**PLANNING COMMISSION AGENDA  
MARCH 16, 2023 – 6:30 P.M.**

**Planned Unit Development Amendment – Lots 1-3  
& Outlot A Southport West Replat Eight –  
Southport Parkway, LLC**

**CITY OF LA VISTA  
PLANNING DIVISION  
RECOMMENDATION REPORT**

RE: Planned Unit Development Amendment – Initial Review Letter  
Lots 1, 2, 3, and Outlot A Southport West Replat 8

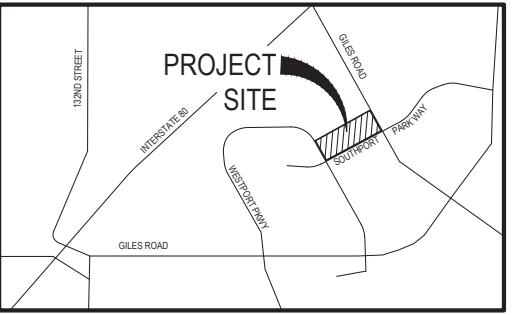
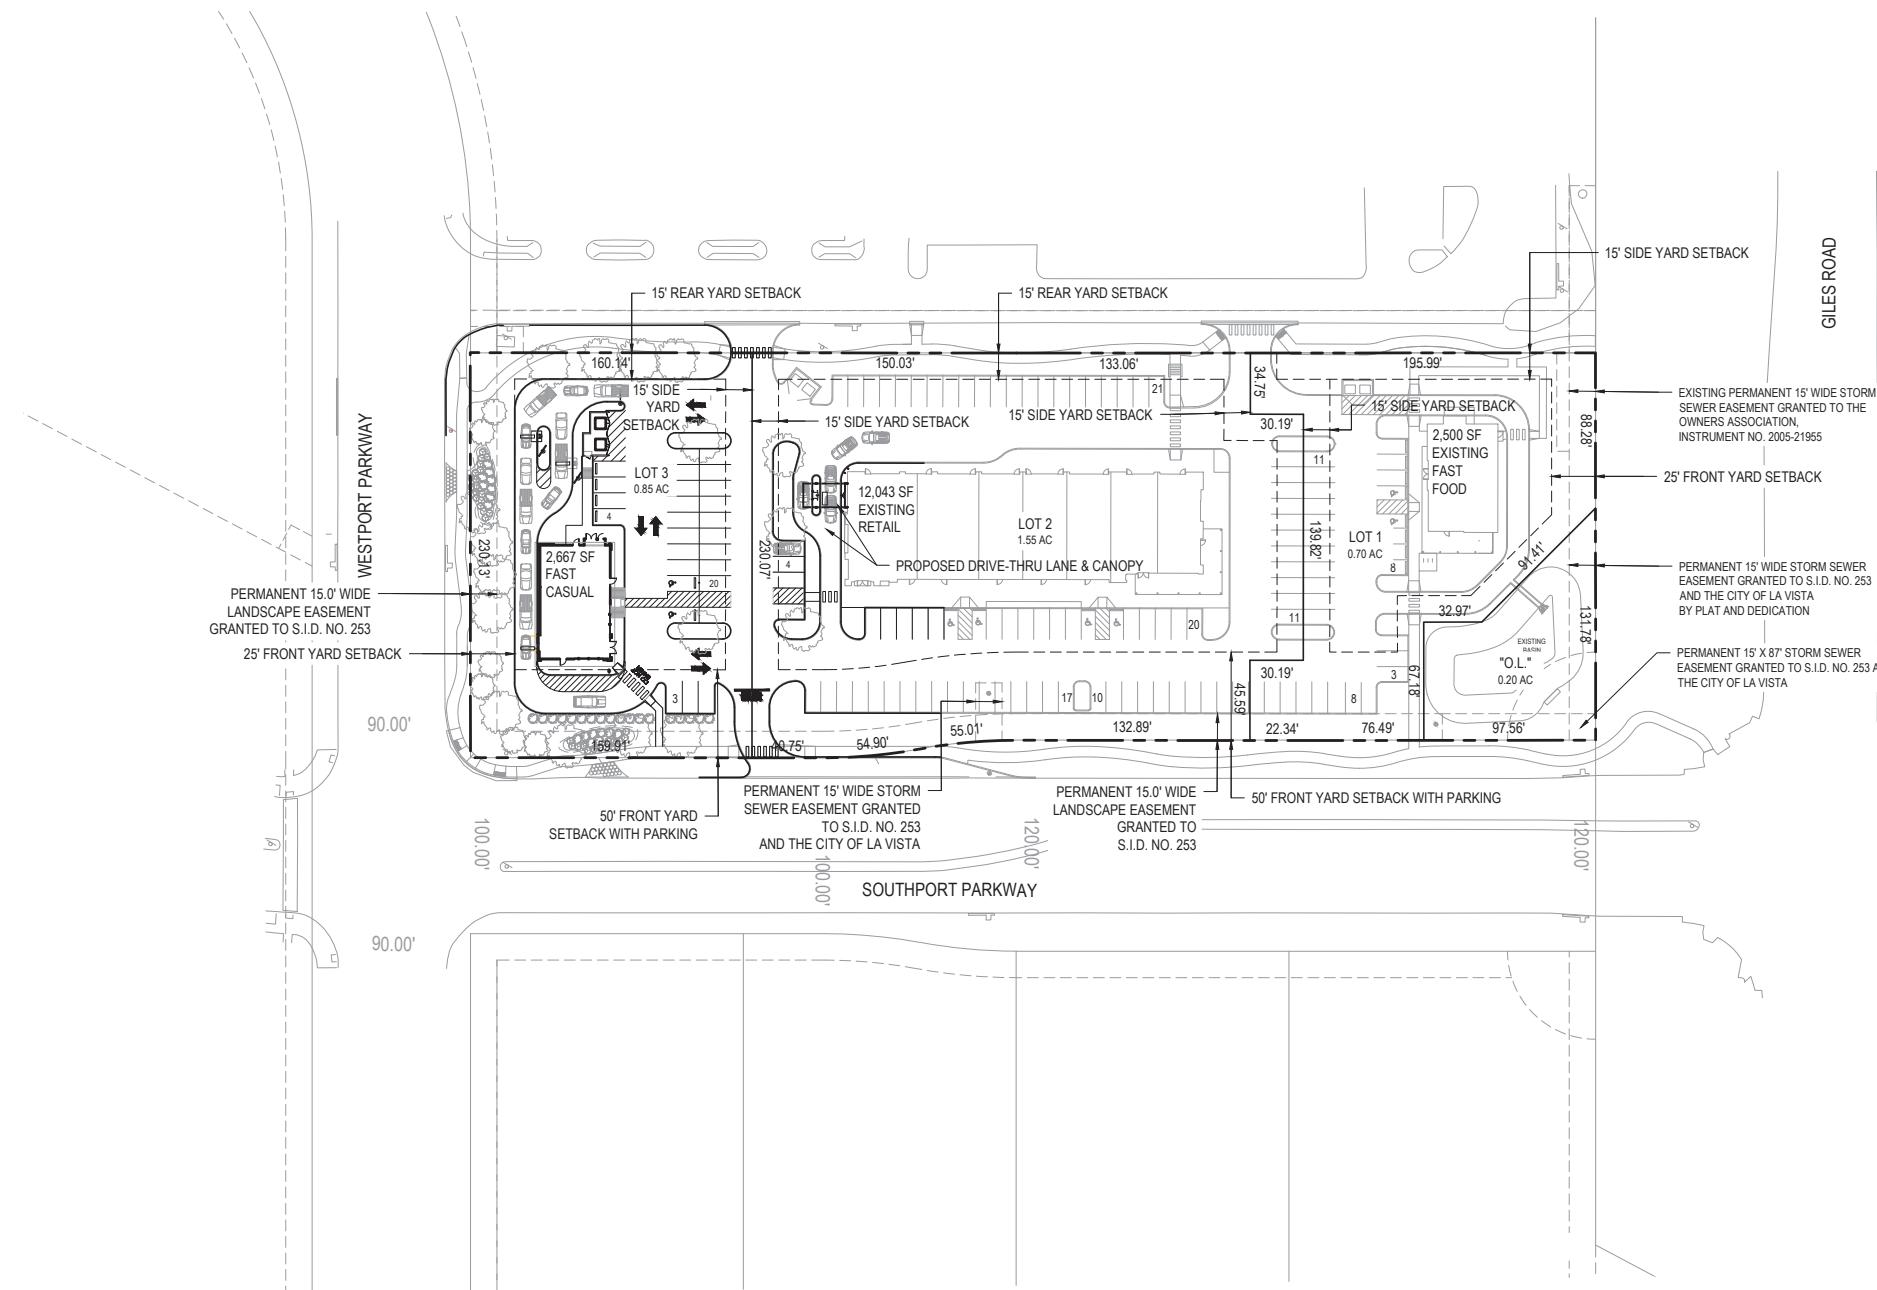
1. As per Section 5.15.5.06 a vicinity maps needs to be included in the PUD Site Plan that meets the requirements of the aforementioned section of the Zoning Ordinance. Although a vicinity map has been provided on the latest submittal, the location it depicts is wrong.

*Response: The Vicinity Map has been revised as noted.*

**PLANT SCHEDULE**

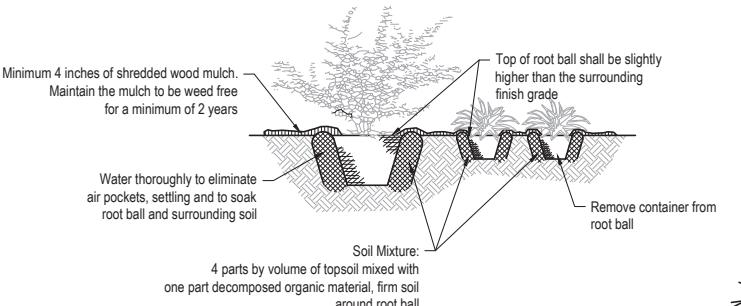
1. Landscaping
  - i. Plants with type marks B, C & E on the planting schedule are not included in the approved plant list in appendix C.

*Response: This revision has been completed.*
  - ii. Deciduous shade trees are required to have a 3" caliper. Trees proposed in Planting Schedule is shown as a 2" caliper, revise as required.

- iii. Deciduous shrubs are required to be 5 gallons. Shrubs proposed in Plant Schedule is shown as a 3 gallon, revise as required.  
*Response: This revision has been completed.*
- iv. 6.I.C requires a' bermed, landscaped, sodded and irrigated green space along secondary (Southport Parkway & Westport Parkway) street frontages. The grading plan does not indicate any bermming along these frontages.  
*Response: This revision has been completed.*

*Response: This revision has been completed.*

**Figure 9. Site circulation conceptual improvements**

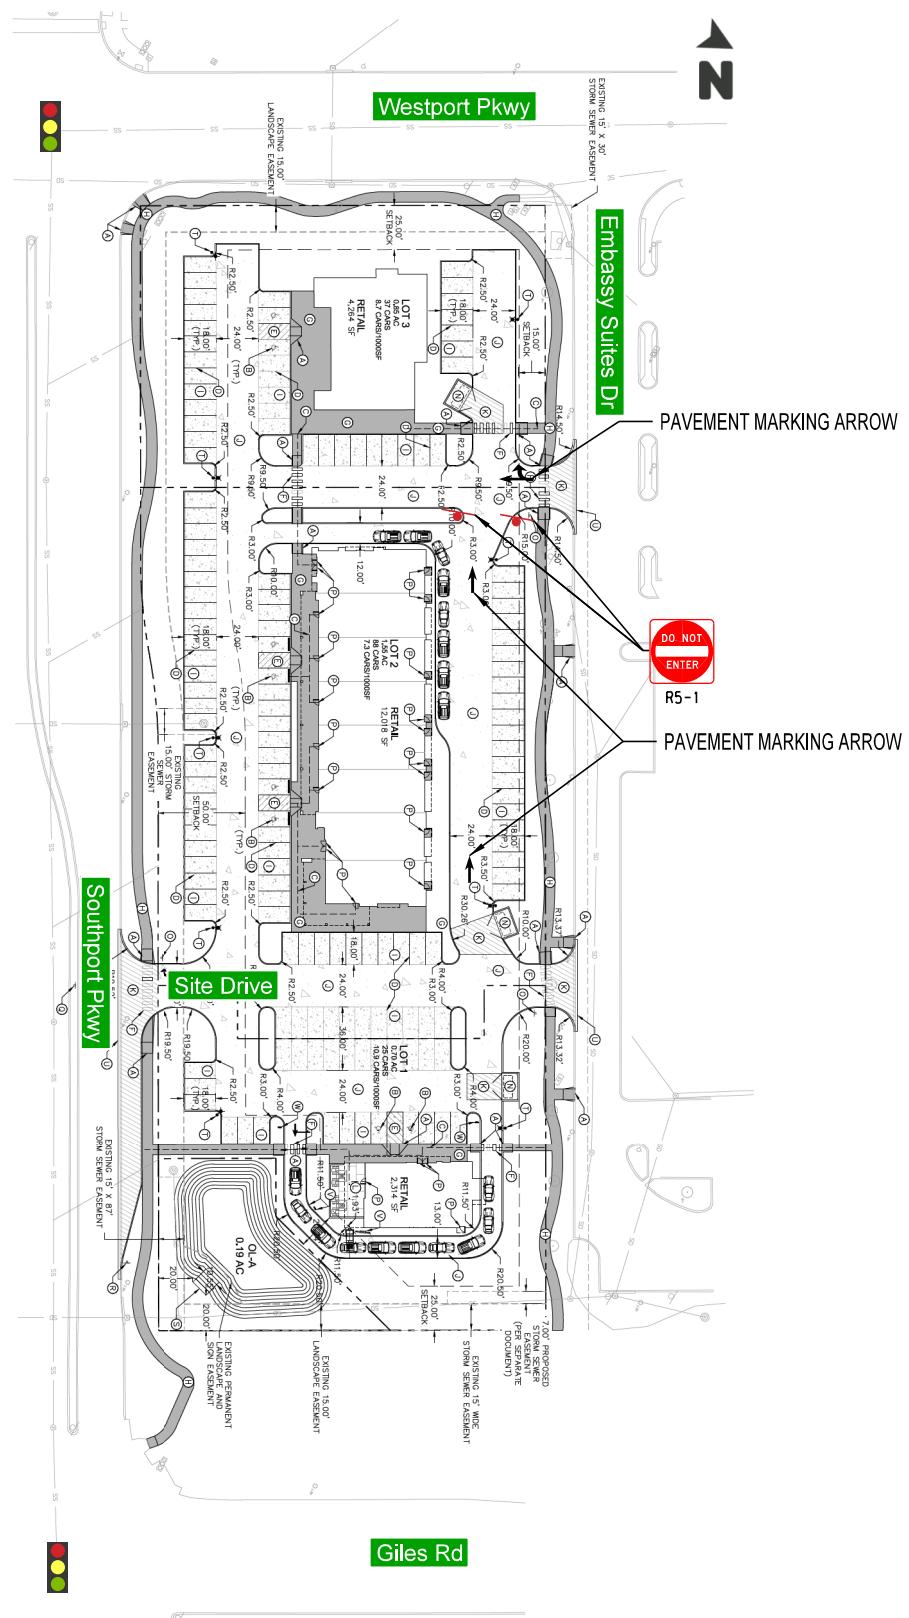
The available stacking for the fast-food restaurant (center building) shown in the site plan is eight vehicles in a dedicated storage lane. The 24-foot drive aisle on the north side of the building should be one-way westbound to avoid conflicts with circulation and drive-through access. Do Not Enter (MUTCD sign R5-1) signs and pavement marking arrow symbols should be installed to guide site traffic. **Figure 9** shows a concept of these signage and pavement marking improvements.

Based on the current site plan, the drive aisle on the north side of the central building should be one-way westbound to avoid conflicts with circulation and drive-through access. Do Not Enter (MUTCD sign R5-1) signs and arrow pavement markings should be installed to guide site traffic.
